OFFICE OF LICENSING & GUIDANCE

INSPECTORS REPORT ON A LICENCE APPLICATION

| RE: | APPLICATION FOR A WASTE LICENCE FROM FINGAL COUNTY COUNCIL, LICENCE REGISTER W0231-01 | |

Figure 2: Clay thickness contour plot

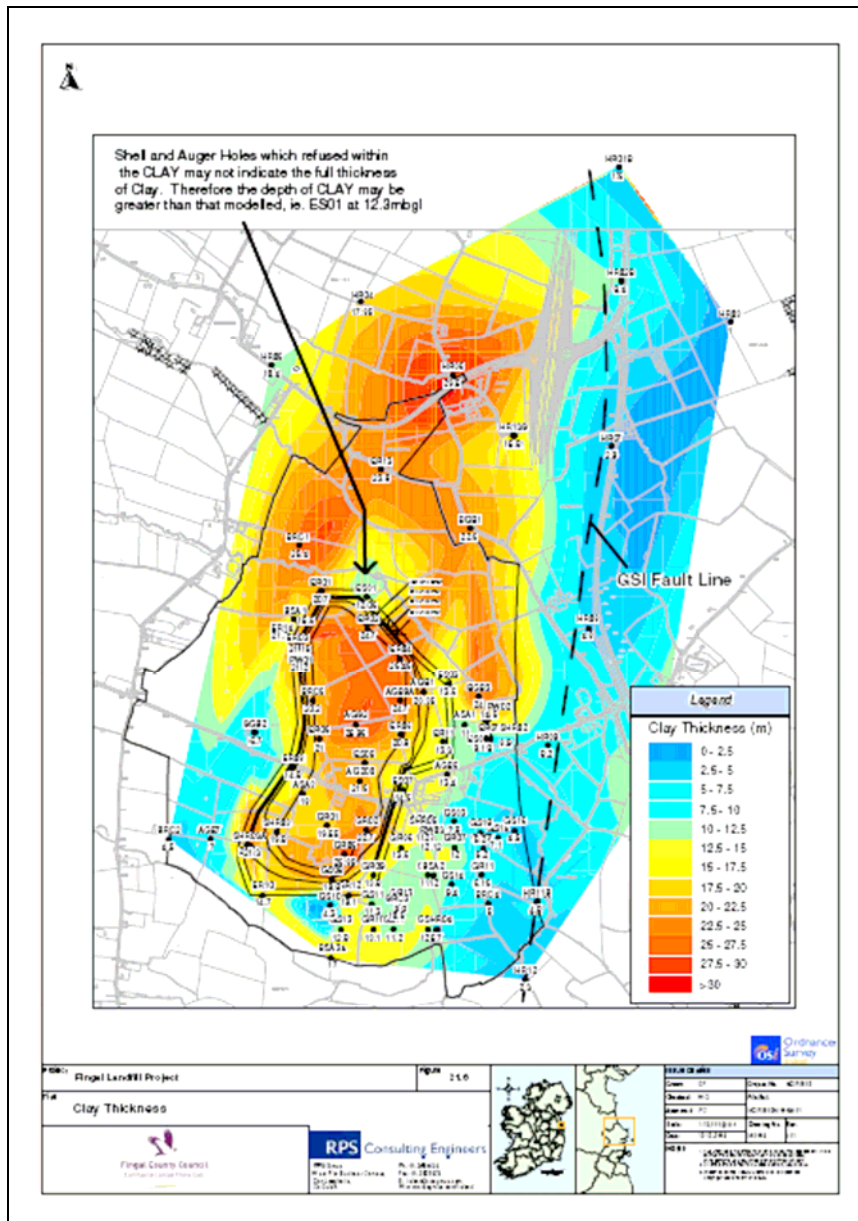
The applicant has committed to retaining at least 10 metres of in-situ low permeability subsoils below the landfill footprint after excavation. This would result in a vulnerability rating of 'Low' according to the National vulnerability mapping guidelines (DELG, EPA, GSI, 1999). The site boundary and landfill footprint are reported to extend across the Lucan, Naul and Loughshinny bedrock formations. These have been classified by the GSI as 'locally important bedrock aquifers which are generally moderately productive (Lm)'. Combining this aquifer classification and vulnerability for the landfill footprint results in a classification under the 'Response Matrix for Landfills' of R1: 'Acceptable subject to guidance in the EPA Landfill Design Manual or conditions of a waste licence'.
